BUKA ENVIRONMENTAL Boulder, CO 80302 USA 303.324.6948/aamaest@gmail.com www.buka-environmental.com

Memorandum

- **To**: John Robison, Public Lands Director, Idaho Conservation League; Pete Dronkers, Southwest Circuit Rider, Earthworks; and Judy Anderson, private citizen
- From: Ann Maest, PhD; Buka Environmental
- Date: 27 October 2020
- **Re**: Evaluation of the Draft Environmental Impact Statement (DEIS) for the Stibnite Gold Project, Idaho, and Related Water Quality Conditions, Predictions, and Effects

Figure 1b. Temporal variability in specific conductance as a function of stream discharge, USGS Gage 13311000, 2012-2018, EFSFSR near YP-SR-10, downstream of Meadow Creek confluence and upstream of Garnet Creek. Red circles show peaks associated with the rising limb of the snowmelt hydrograph.

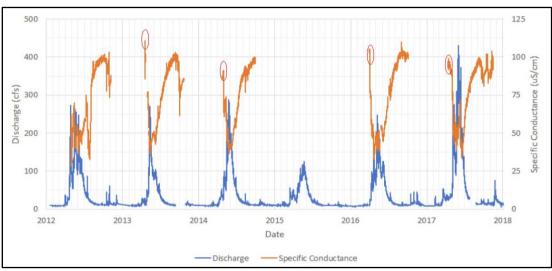
One of the most distinctive features of site surface water quality is the temporal variability in concentrations associated with stream hydrographs. At sites affected by mine contaminants with notable temporal variability, it is important to know the maximum concentrations because they could cause acute, short-term toxicity to aquatic biota, depending on the element and the maximum concentrations. Knowledge of maximum concentrations is also important for assessing the effectiveness of cleanup and mitigation measures. Surface water monitoring is often not frequent enough or well-timed with the snowmelt hydrograph to identify temporal changes and maximum concentrations. As shown in Figure 1a, some samples associated with the rising limb of the snowmelt hydrograph (March – April, depending on the year) were collected, and those samples had the highest antimony concentrations and had high arsenic concentrations. Figure 1b shows conductivity values, which can be measured more frequently in, for example, automatic samplers, and obvious peaks in conductivity also occur on the rising limb of the snowmelt hydrograph.

Because the SWWC model is based on annual average conditions, these temporal changes are not well represented in the model. A "patch job" was done using monthly Seasonal Adjustment Factors (SAFs) to account for the temporal variability, but these adjustments only operate on a monthly level and would not capture peaks that could occur over shorter timeframes (see Section 5.2.2 of this memorandum). The same monthly adjustment factor is used for all years, regardless of interannual peak or other seasonal flow variability. The SWWC model report (SRK Consulting, 2018) states that concentrations were typically lowest during the spring snowmelt when flow rates were highest, and most exceedances occurred during low flow conditions. Figures 1 A and B show that antimony and specific conductance values are often higher during rising flows than high or low flows. Arsenic concentrations are highest during low flow, but not enough sampling was conducted during the rising limb; specific conductance was measured much more often. The high values for specific conductance during the rising limb are an indication that more sampling would have revealed higher contaminant concentrations during the rising limb.

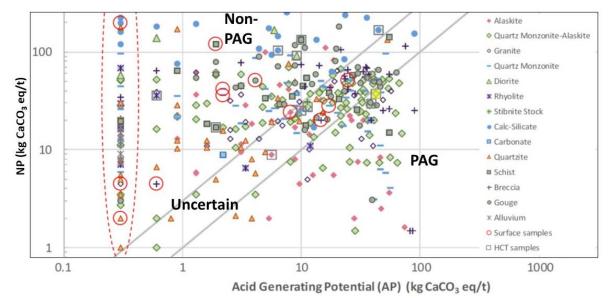
Figure 2 shows that categorizing waste rock based solely on lithology is inadequate. Notice that alaskite, quartz monzonite-alaskite, quartz monzonite, schist, gouge, and breccia samples span from non-PAG to Uncertain to PAG. This is a good indication that more divisions should have been made within the lithologic units (geochemical or geoenvironmental test units) to ensure the units had at least somewhat similar acid-generation and contaminant leaching potential. Quartz monzonite is the most common rock type in the Yellow Pine pit (25%), the Hangar Flats Pit (54%), and the Fiddle DRSF (64%) (DEIS, Tables 4.9-1, 4.9-3).

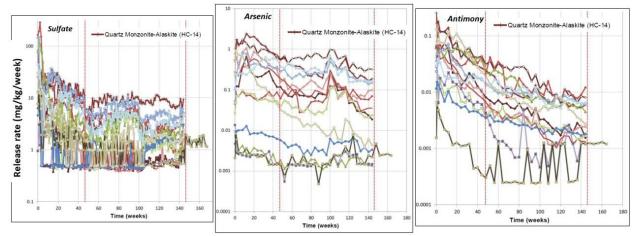
"Steady-state" conditions related to HCT release rates are defined in SRK Consulting (2018, p. 28) as "stable effluent sulfate concentrations (within ±5 milligrams per kilogram per week [mg/kg/week])."⁵ In the same report, SRK Consulting (p. 46) makes the following statement: "Arsenic and antimony release rates in the HCTs are strongly correlated to sulfate release (Figure 4-15 and Figure 4-16), therefore the attainment of steady-state release for sulfate occurs at the same rate and at approximately the same time as for arsenic and antimony." The trends in arsenic and antimony release rates are not at all well correlated with sulfate release rates, and the rates are not the same. As shown in Figure 3, while sulfate release rates for the one PAG sample used in site modeling (HC-14) are relatively steady in the timeframe selected by SRK Consulting (see SRK Consulting, 2018, Table 4-5 for weeks and samples chosen to represent model source terms), arsenic and antimony release rates are not. Using this time period also eliminates early-week first-flush releases, which should be used to represent the variability in release rates. Table 4-6 (SRK Consulting, 2018) lists release rates used for the HCT development rock samples that were weighted "to reflect the lithologies contained within each block modeled solid." However, the document does not clearly or specifically describe how they arrived at the rates in Table 4-6. Figures 4-13 and 4-14 show the single source terms for Yellow Pine and Hangar Flats intrusives, again showing that the variability in arsenic and sulfide values are not represented.

- Average steady-state release rates are used for all analytes for the same weeks that sulfide releases reached steady state conditions. As shown in Figure 3 in this memorandum, steady-state rates were possibly reached for sulfate but not for arsenic or antimony.

Figure 5. Partial conceptual model of the TSF showing movement of consolidation water from all parts of the tailings.

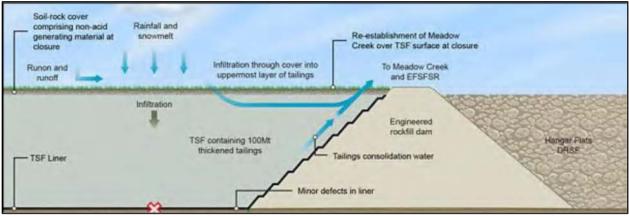
- During post-closure, the results from SPLP leachate are used to estimate the chemical composition of infiltration through the TSF cover. It is unclear from the discussion in SRK Consulting (2018; Section 5.4.1 and Tables 5-3 and 5-4) how these results will be mixed with the chemistry of seepage through the liner. A sensitivity analysis should be conducted that examines a range of assumptions of mixing to evaluate the resulting TSF leachate under the facility.

- Tailings water quality is represented by five tailings streams (DEIS, Table 4.9-9). During post-closure tailings water quality is represented only by the process water chemistry of West End oxide and sulfide tailings, which will be produced in the later stages of mining and will be therefore by on the top of the TSF (DEIS, p. 4.9-19). The TSF model assumes that most consolidation water would be derived from the upper parts of the TSF during post-closure. However, DEIS Figure 4.9-7, reproduced in part in Figure 5 below, shows consolidation water coming from *all* parts of the tailings and moving upward. Infiltration water may only affect the upper materials, but consolidation water comes from the entire column.
